Access Compliance Report

Public Rights-of-Way

(Curb Ramps)

Intersection ID: 14373	Main Street: EAST_BV	Cross Street: LYNDHURST_AV	Location: SW
ADA ID: 01668E901EFF	Ramp Type: Perp	Initial Pass/Fail: Fail	Overall Compliance: No
Codes/Mitigation Info/Possible Solution		Field Measurements/Component Compliance	
Severity Score: 12.5

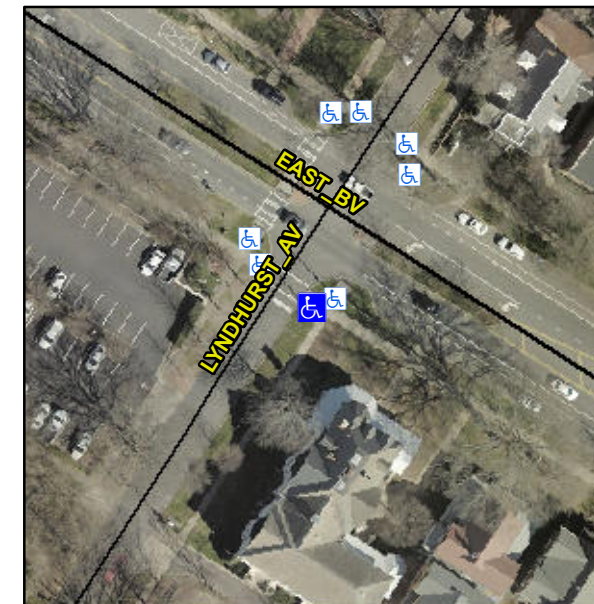
Not Found, R304.2.2

Compliance	Description	Data	Compliance	Description	Data
N/A	Ramp Length (in)	67.5	No	Ramp Slope (%)	9.2
Yes	Ramp Width (in)	72.0	Yes	Ramp XSlope (%)	1.4
N/A	Flare Type LT	N/A	N/A	Flare Type RT	N/A
N/A	Flare Slope LT (%)	N/A	N/A	Flare Slope RT (%)	N/A
N/A	Flare Traversable LT?	N/A	N/A	Flare Traversable RT?	N/A
N/A	Landing Length (in)	N/A	N/A	DWS Provided?	N/A
N/A	Landing Width (in)	N/A	N/A	DWS Contrast?	N/A
N/A	Landing Slope (%)	N/A	N/A	DWS Length (in)	N/A
N/A	Landing X Slope (%)	N/A	N/A	DWS Full Width?	N/A
N/A	Landing Curb? (Y/N)	N/A	N/A	DWS Offset (in)	N/A
N/A	Shared Landing?	N/A			
N/A	Gutter Ponding?	N/A	N/A	Gutter Slope (%)	N/A
N/A	Gutter Lip Ht (in)	N/A	N/A	Gutter X Slope (%)	N/A
N/A	Painted X Walk1?	Yes	N/A	Painted X Walk2?	N/A
	X Walk 1 Direction	To NW		X Walk 2 Direction	N/A
N/A	X Walk 1 Width (in)	112.0	N/A	X Walk 2 Width (in)	N/A
	X Walk 1 Slope (%)	4.8		X Walk 2 Slope (%)	N/A
	X Walk 1 X Slope (%)	2.8		X Walk 2 X Slope (%)	N/A

Remove & Replace Entire Ramp.
